Technical Memorandum 8-60

HUMAN FACTORS ENGINEERING EVALUATION
OF THE
M60 MAIN BATTLE TANK

This study reports the results of an evaluation of the M60 Tank from a human factors engineering standpoint. The report is primarily concerned with noise evaluation and crew area evaluations to determine their conformity with human factors design practices.

Fig. 1. Octave band measurements of the noise in the turret of the M60 Tank at 30 mph and 10 mph

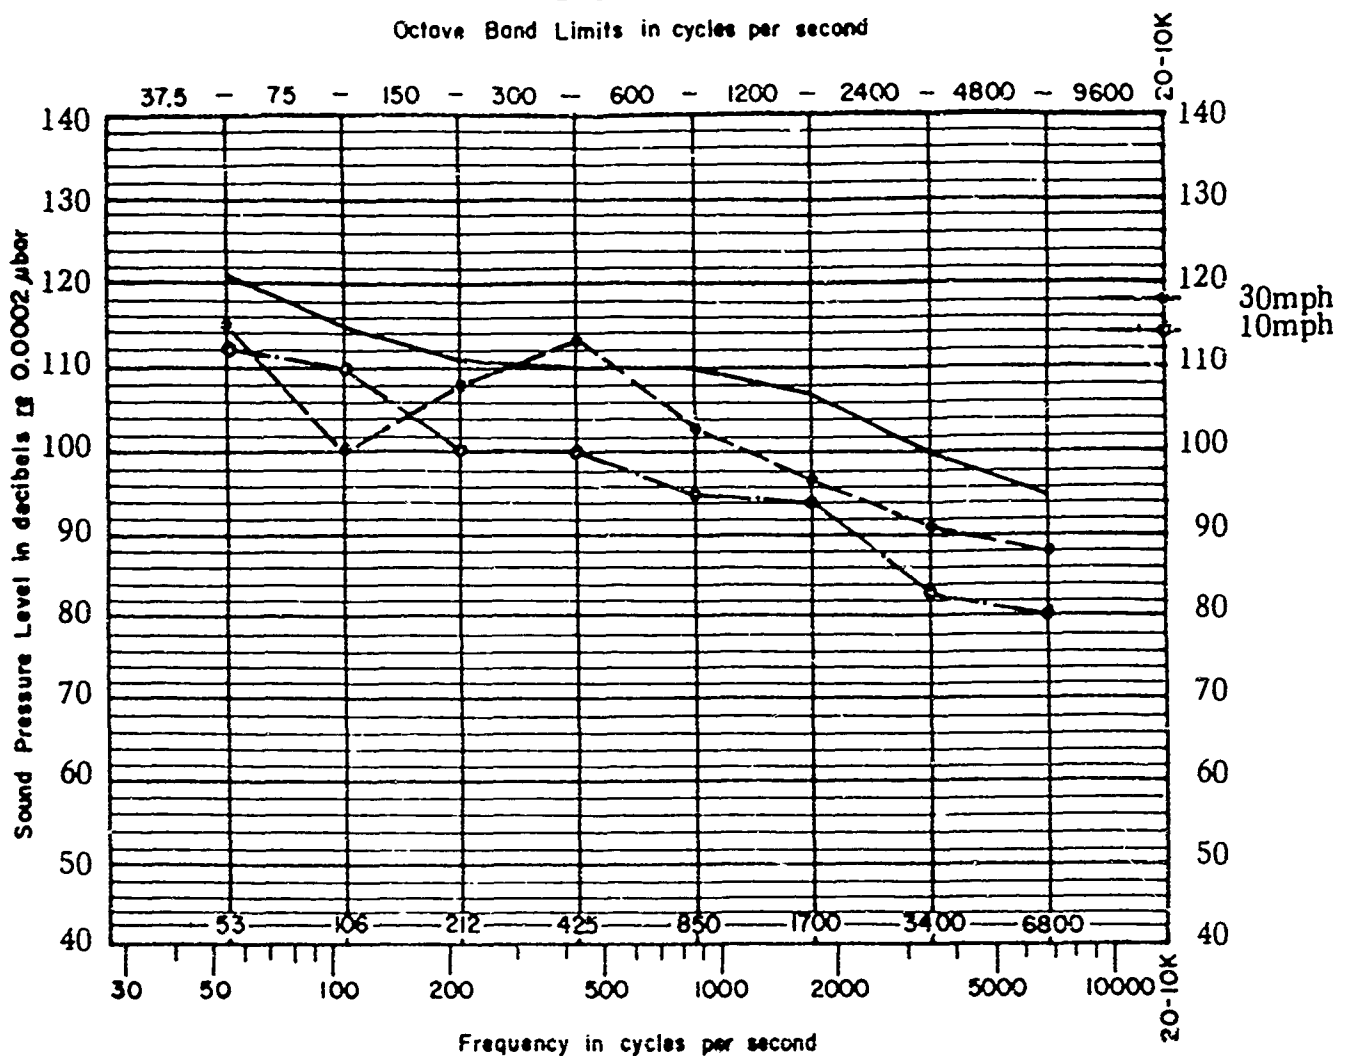
An octave band analysis of noise in the turret at speeds of 30 mph (high range) and 10 mph (low range) was also conducted. At 500 cycles per second, the sound pressure level exceeds the Human Engineering Laboratories' maximum sound pressure level standard for that octave band by 3 db. This deviation from the recommended limit is negligible and no action, in terms of additional sound attenuation, is recommended.
